UNITED STATES
NUCLEAR REGULATORY COMMISSION
WASHINGTON, D. C. 20555

APPLICANT: Texas Utilities Electric Company (TU Electric)
FACILITY: Comanche Peak Steam Electric Station (CPSES), Units 1 and 2
SUBJECT: SUMMARY OF MEETING ON MARCH 17-18, 1988 -
COMANCHE PEAK FIRE PROTECTION PROGRAM

On March 17-18, 1988, the staff met with representatives of TU Electric, lead applicant for the CPSES, to discuss (1) the status of TU Electric actions related to open and unresolved items in NRC Inspection Report 50-445/87-22 and (2) information needed by the staff to complete its revised safety evaluation on the fire protection program for the CPSES Units 1 and 2. The meeting notice, agenda, and list of attendees are provided as Enclosures 1, 2, and 3, respectively, to this summary. The handouts used by the applicant are included as Enclosure 4.

OPEN ITEM 445/8722-0-03

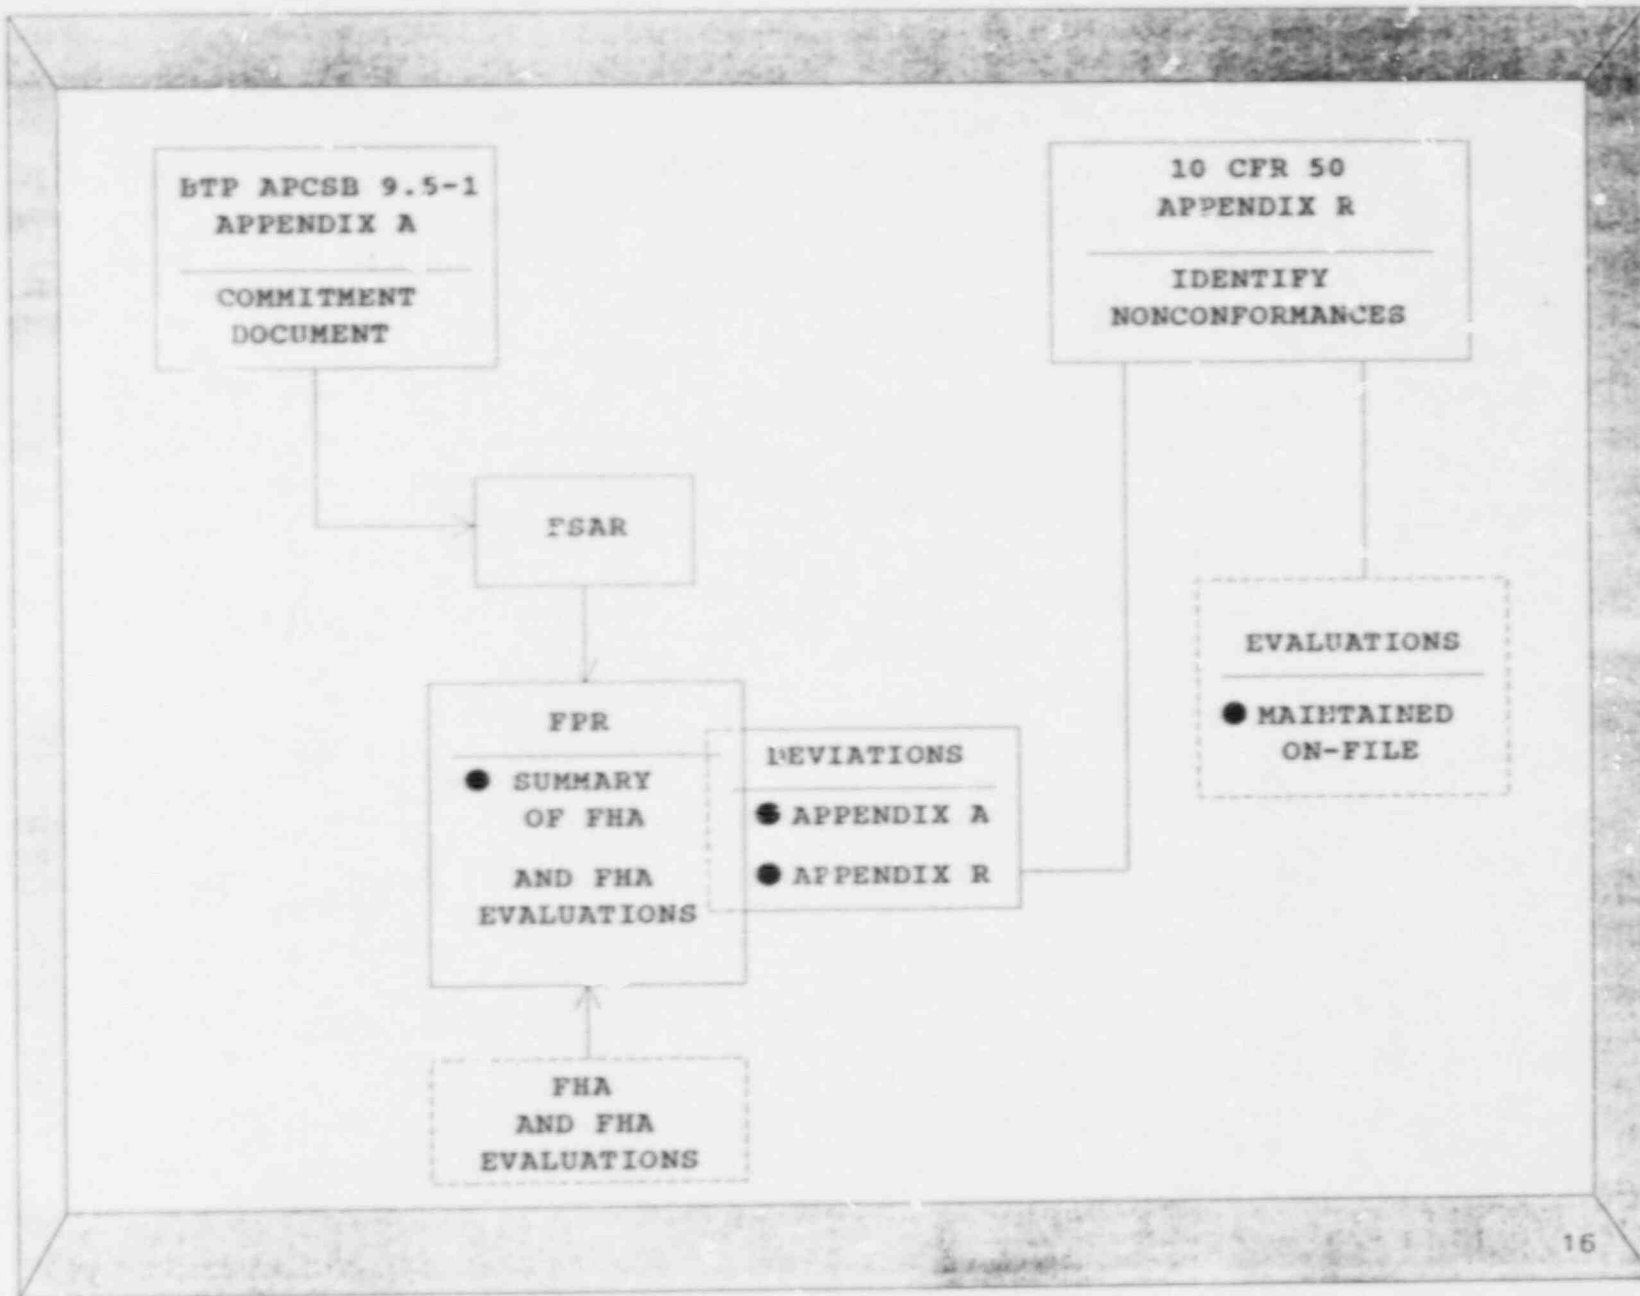
COMMIT TO SEAL CONDUITS FOUR INCHES AND SMALLER ON BOTH SIDES AT THE FIRST OPENING. SEAL INSTALLATION COMPLETION

- UNRECOGNIZED COMMITMENT UNDER REVIEW

- RESPONSE APRIL 29, 1988
